FINAL RESUBMITTAL

Re: Special Use Permit – Applicant Statement Resubmittal #UP20-00008

American Legion Post 48 Zoning Design Standards LRSN(s) 12001405/12001406

PROPOSED BUILDING FOR AMERICAN LEGION POST 48 115 & 117 SOUTH MALLORY STREET, HAMPTON, VIRGINIA

IN SHEET DESCRIPTION
IN SET #
1 T-1 TITLE SHEET, CODE DATA & SHEET LIST

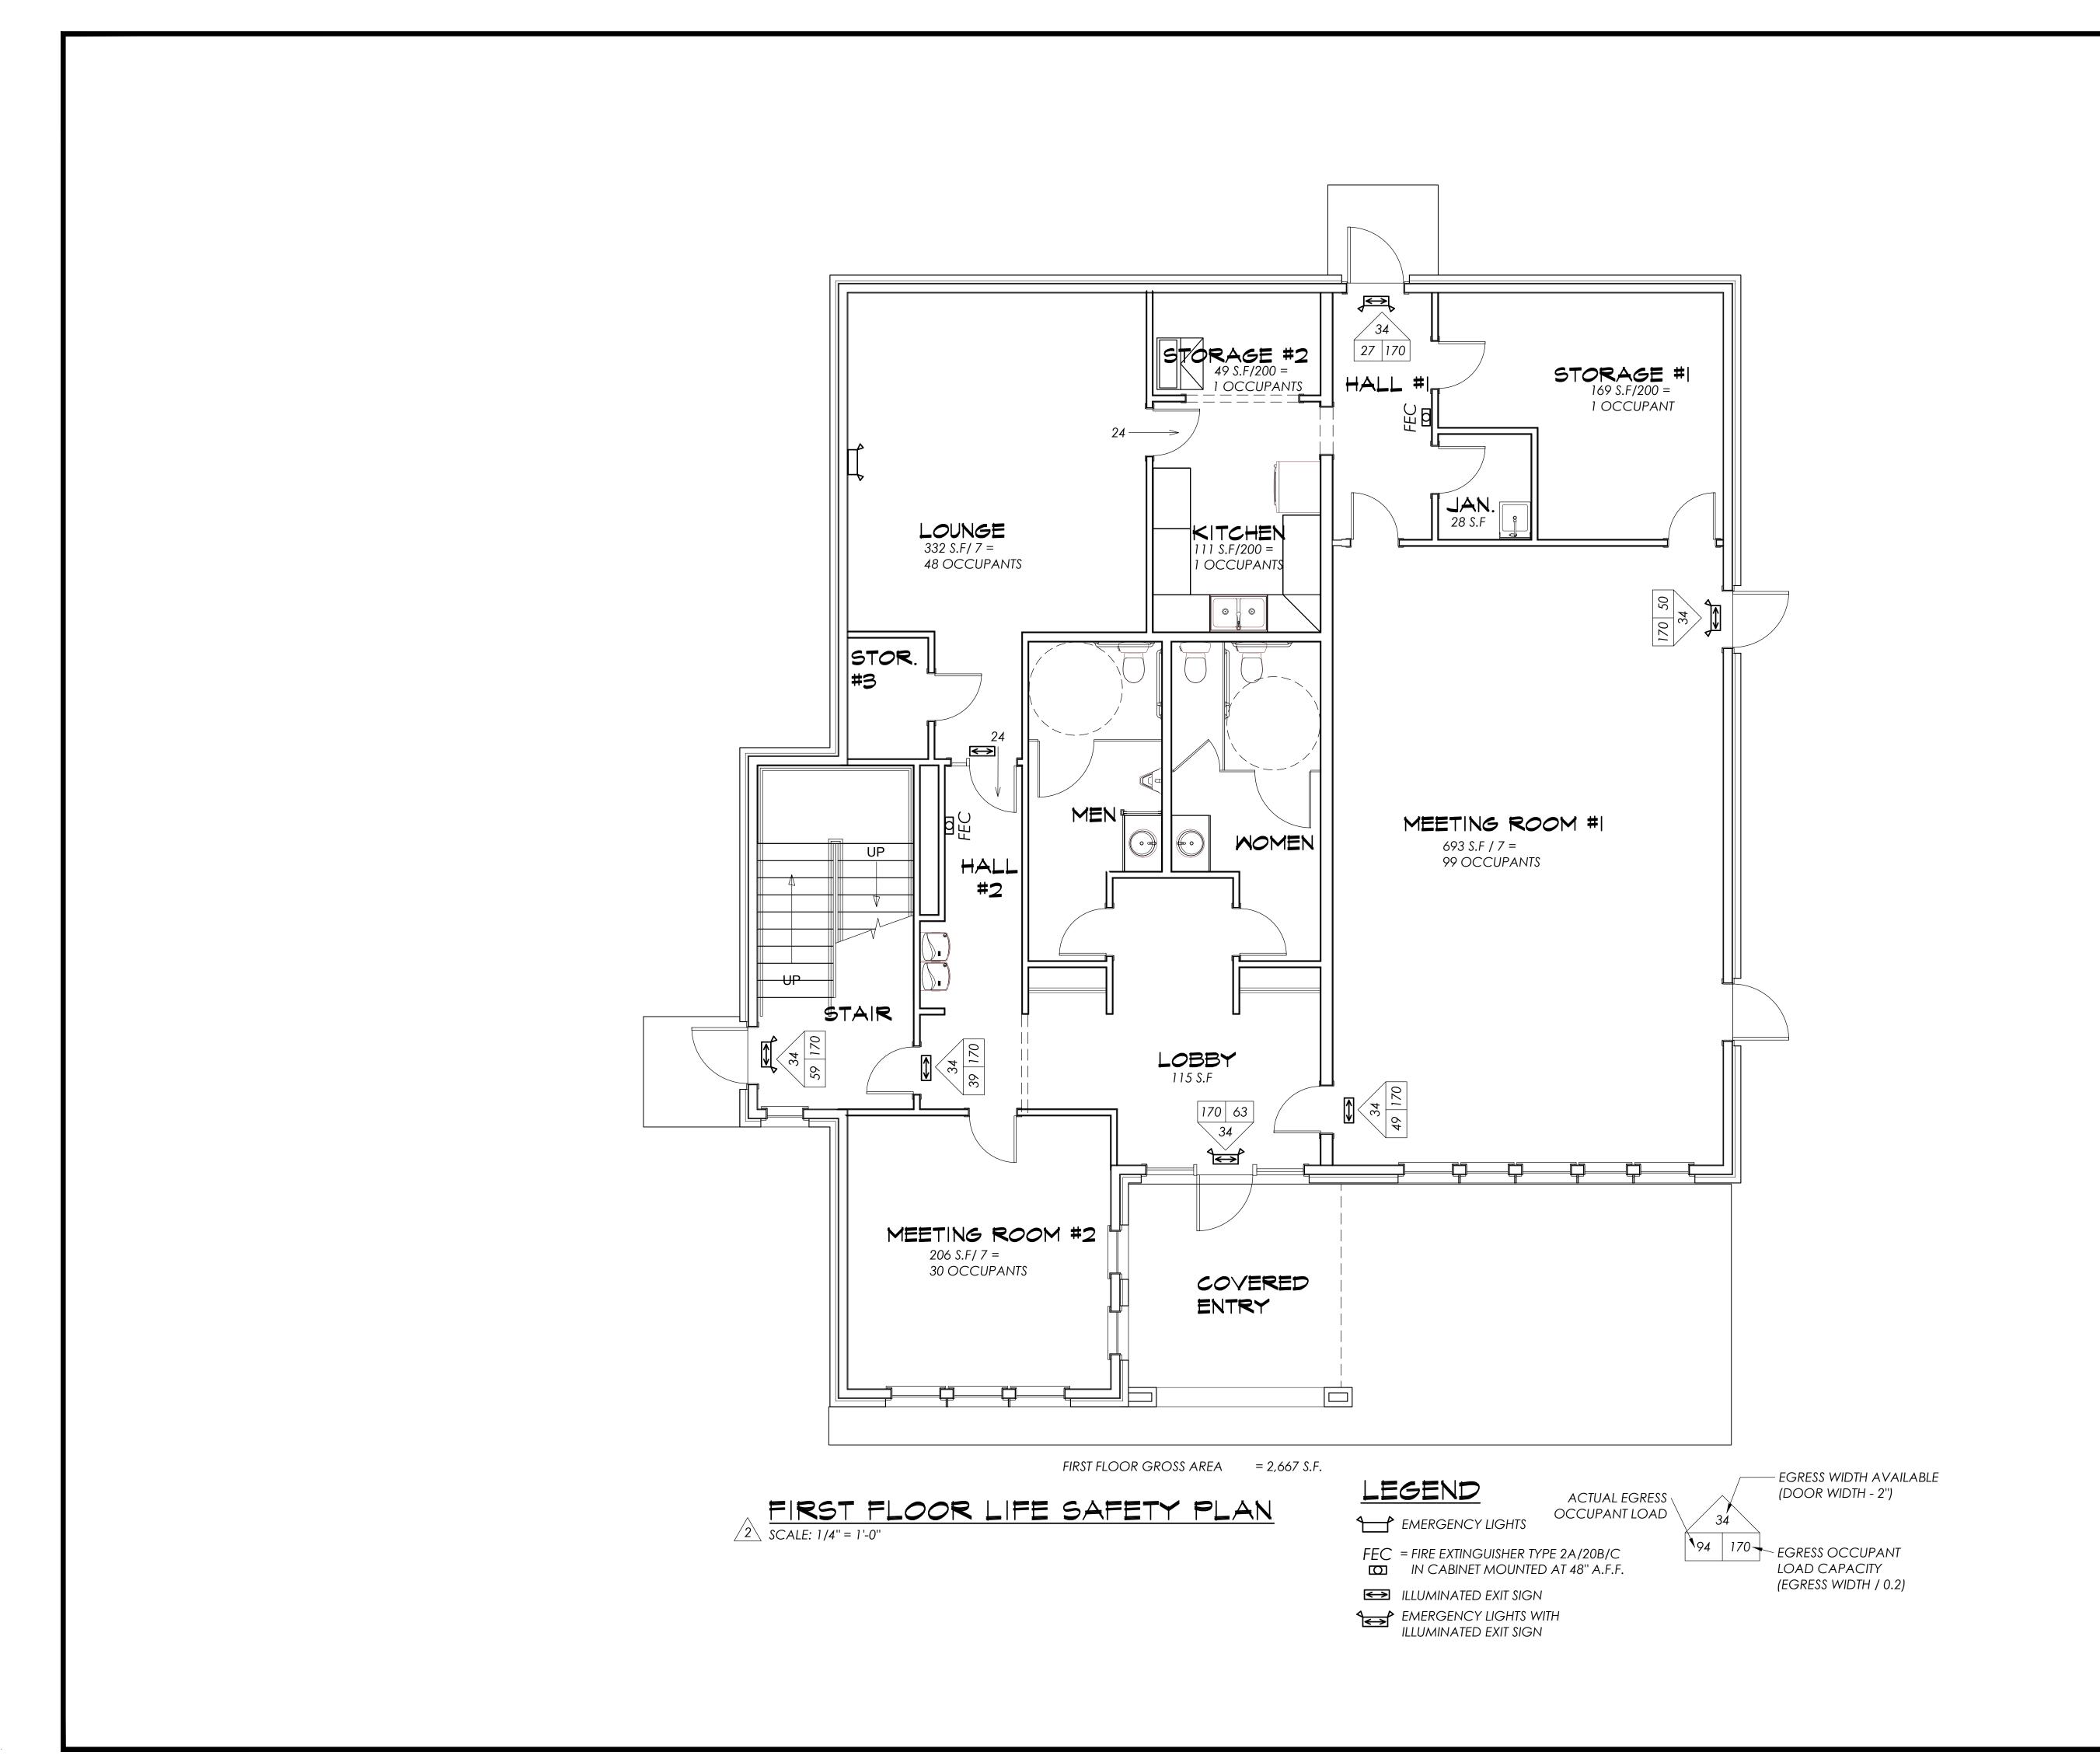
6. Where ground floor commercial space fronts on a public right-of-way, a minimum of 40 percent of the first floor building façade containing the primary entrance shall be comprised of glass windows or glass doors that allow views at least 4 feet into the interior building space. It may be possible that this standard is being met, but our office will need to see a scaled, architectural elevation of the building in order to confirm this. Please provide the scaled, architectural elevations. [ZO Sec. 8-62.(3)(e)(iv)(aa)]

The revised front elevation is attached. The larger windows and glass entry door now exceed 40% of the first floor wall area. The calculations are listed on Sheet T-1.

MINIMUM REQUIRED GLASS AREA:

FIRST FLOOR OF SOUTH MALLORY STREET ELEVATION 53'-8" WIDE X 10'-0" TALL = 536.7 SF REQUIRED GLASS AREA = 536.7 X 40% = 214.68 SF

GLASS AREA PROVIDED:

TOTAL GLASS AREA PROVIDED = 217.08 SF

WINDOW A: 2'-8" X 6'-0" = 16.02 SF X 6 UNITS = 96.12 SF WINDOW B: 2'-4" X 6'-0" = 13.98 SF X 2 UNITS = 27.96 SF WINDOW D: 2'-0" X 6'-0" = 12.0 SF X 1 UNIT = 12.0 SF ENTRY DOOR, SIDELIGHTS & TRANSOM = 9'-0" X 9'-0" = 81.0 SF ARCHITECT

FRONT ELEVATION-SOUTH MALLORY ST.

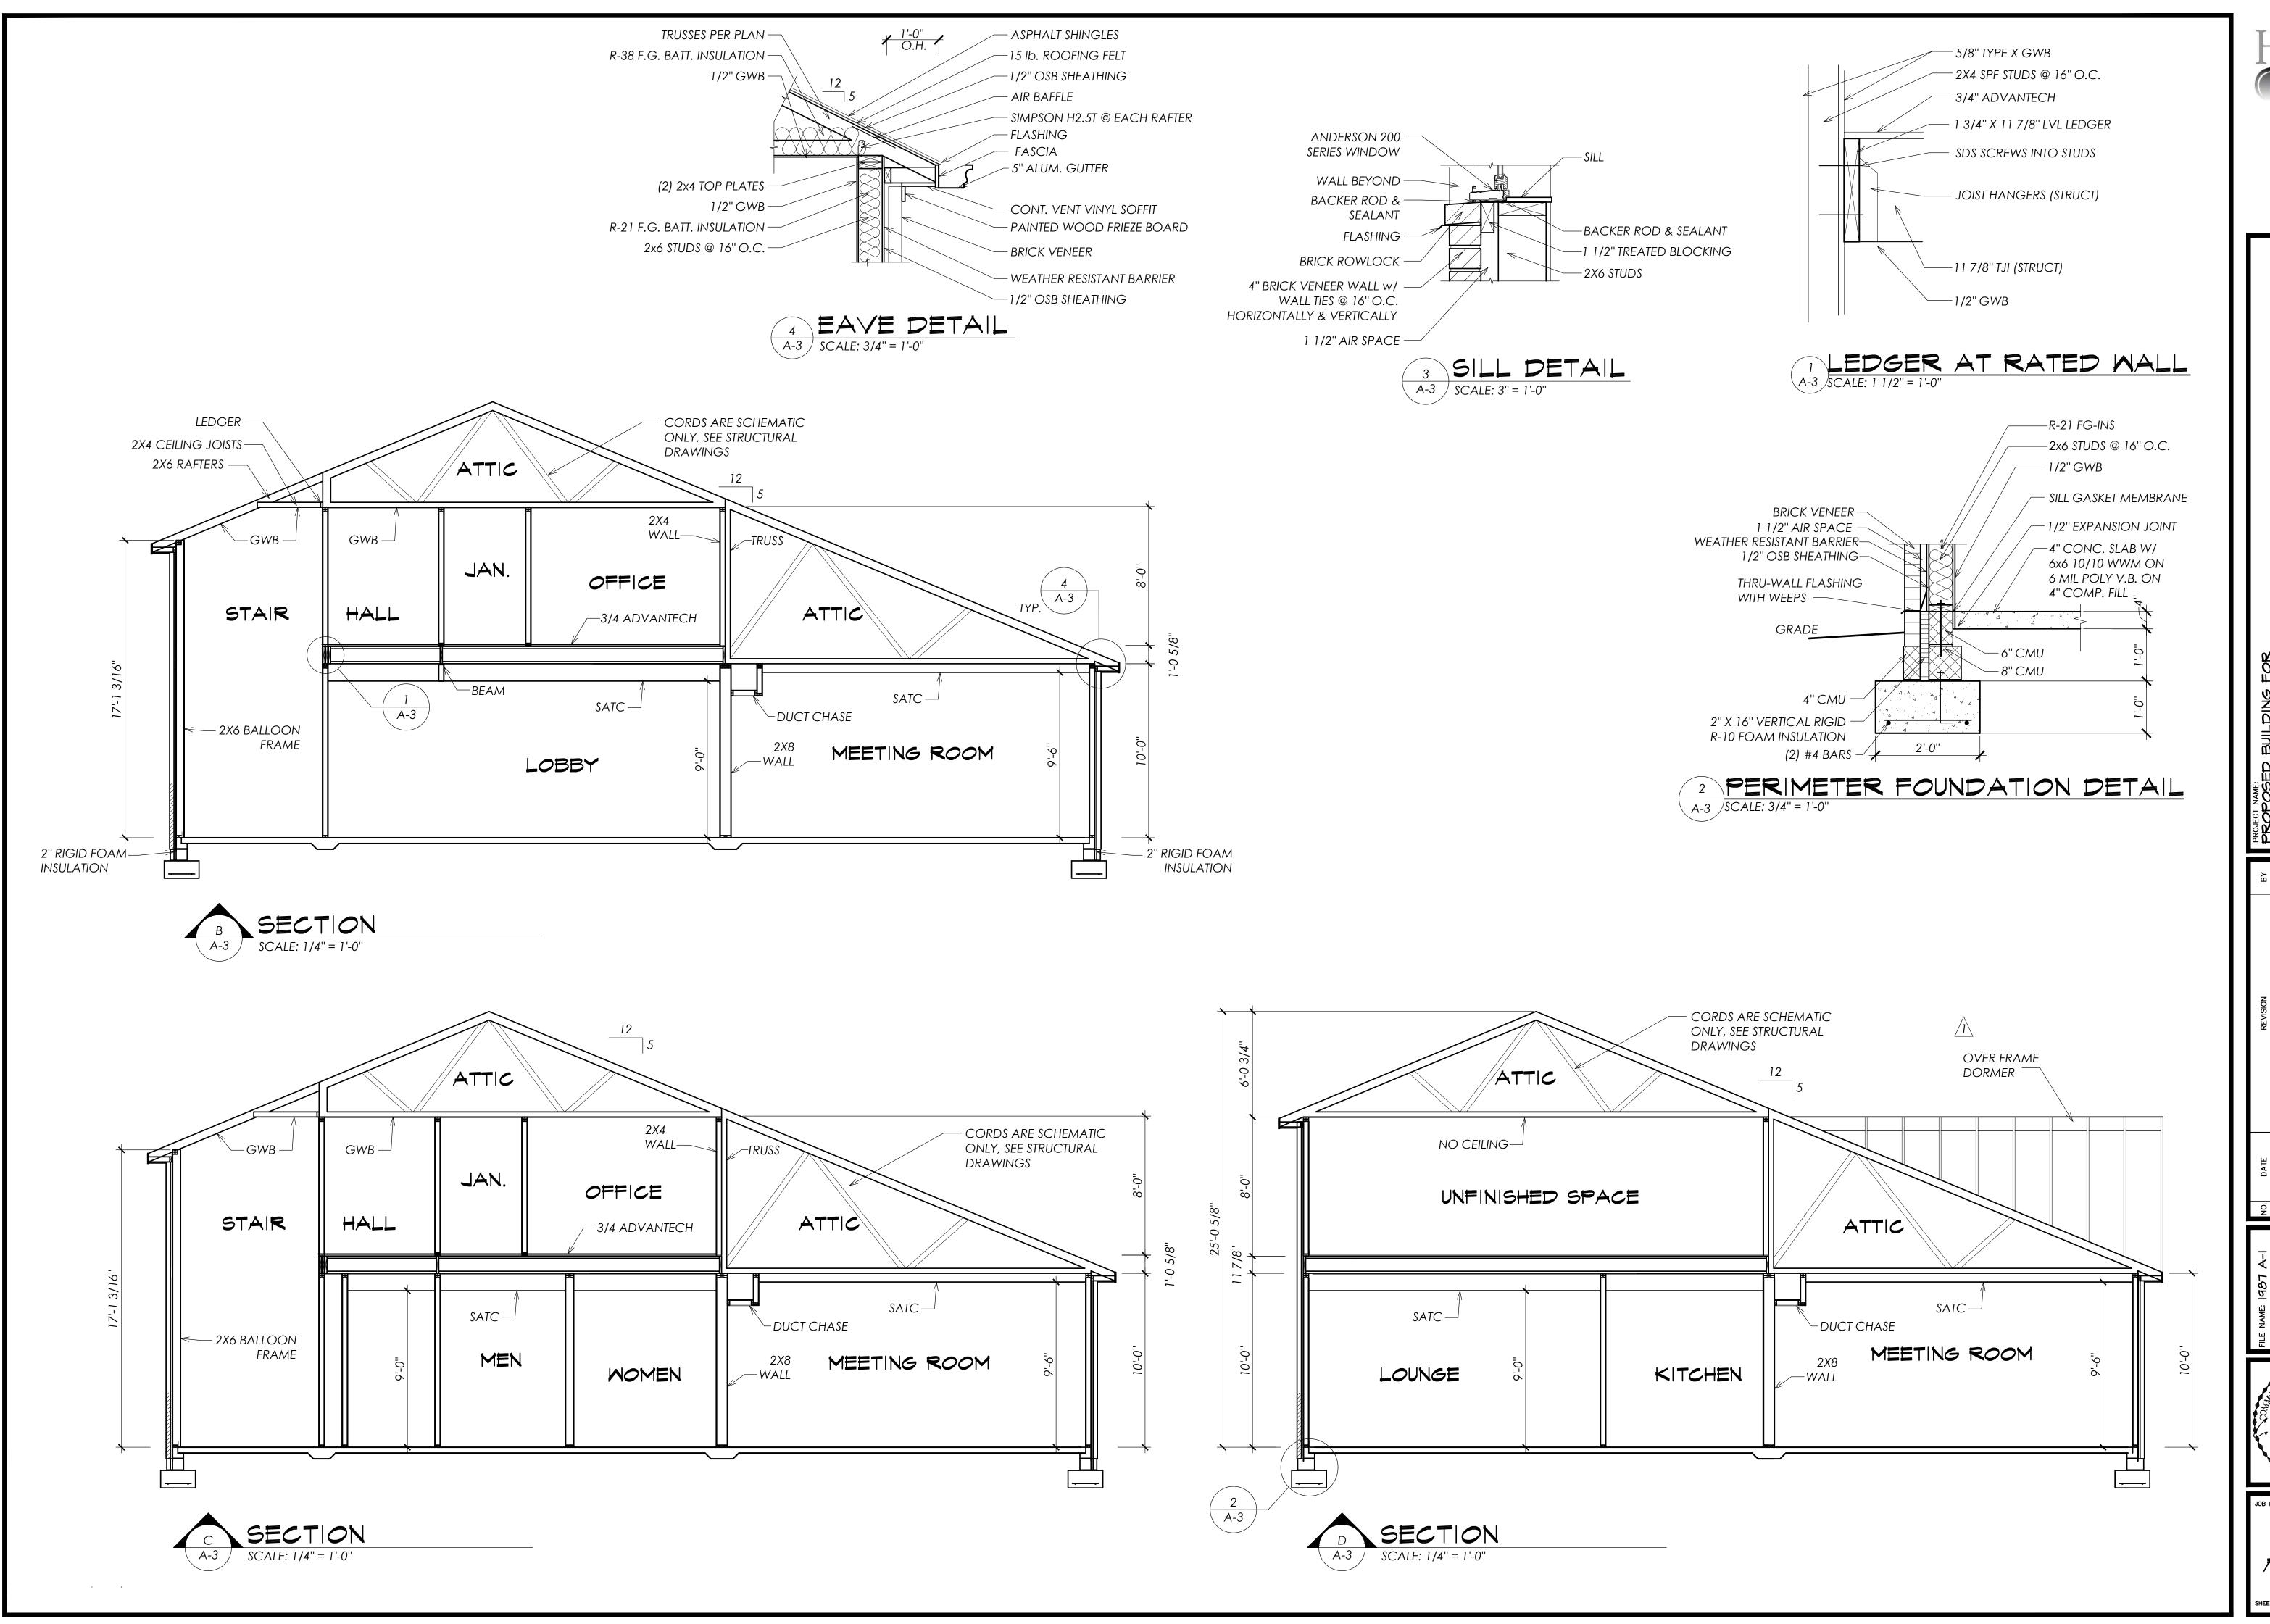
5. The primary entrance to this building shall directly face Mallory Street. The screening of the primary entrance blocks it from view of Mallory Street. Please amend the building plans to reflect this standard or seek the Use Permit. [ZO Sec. 8-62.(3)(e)(ii)(aa) and (bb)]

would use the facility. We have created a large opening in the front courtyard wall to provide a line of sight to the main entrance door, which is glass with large sidelights and transoms.

The blank wall has been penetrated with two large openings, larger glass areas and with signage and plantings facing both streets. A dormer with a window has been added facing Lancer Street.
